VIRGINIA ELECTRIC AND POWER COMPANY
RICHMOND, VIRGINIA 23261

VIRGINIA ELECTRIC AND POWER COMPANY
NORTH ANNA POWER STATION UNIT 2
ASME SECTION XI INSERVICE INSPECTION PROGRAM
RELIEF REQUEST NDE-018

Relief Requests NDE-018

Component: Regenerative Heat Exchanger (2-CH-E-3)

FIGURE NDE-1

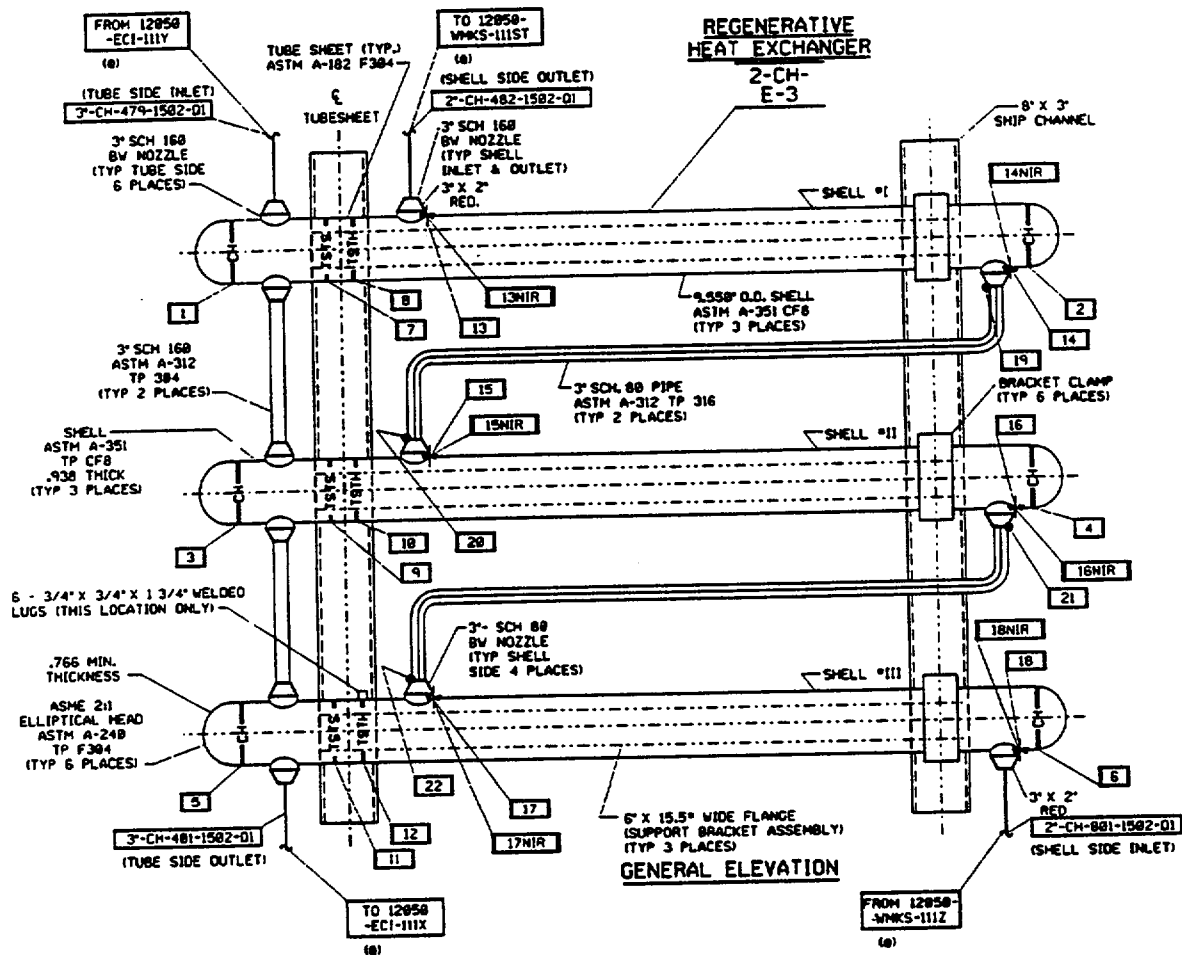
The nozzle-to-vessel welds and nozzle inside radius sections for this vessel were not designed for ultrasonic examination from the outside diameter of the vessel. The small diameter of the vessel and nozzles along with the cast stainless steel vessel shell prevents a meaningful ultrasonic examination of these components.

The Code required volumetric examination on the vessel head circumferential welds is limited due to the weld crown, radius of the closure caps, and the nozzles. The Code required volumetric examination of the tube sheet welds is limited by the weld crown and is obstructed by a support clamp. This clamp must be mechanically removed prior to the welds' examination. Additionally, weld 12 is partially obscured by the three integral attachments, which are themselves butted up against a clamp. It is estimated that between 21 and 42 percent of the circumferential welds could be examined, and 42 percent of the tube sheet welds could be examined, if the clamps are removed. Examination coverage of weld 12 would be significantly less due to the integral attachment location. Previous partial examinations completed on these welds have identified no problems.

Technical Specifications require that the RCS Leak Rate be limited to 1 gallon per minute unidentified leakage. This value is calculated every 72 hours in accordance with Technical Specification requirements. Additionally, the containment atmosphere particulate radioactivity is monitored every 12 hours per Technical Specification requirements. As a result, new leakage is rapidly identified and located during operation. Leakage identified from these components can be easily isolated by two upstream valves with manual operation from within the control room. The valves also receive an automatic control signal to close on inventory loss based on pressurizer level. However, these valves are not Class 1 boundary valves due to their nonsafety-related actuation.

As a result of the reclassification to Class 1, the regenerative heat exchanger components receive a system leakage test prior to start up after each refueling outage. During this system leakage test the components receive a visual (VT-2) examination. The support structures receive a visual (VT-3) examination to the extent required by the Code without insulation removal.
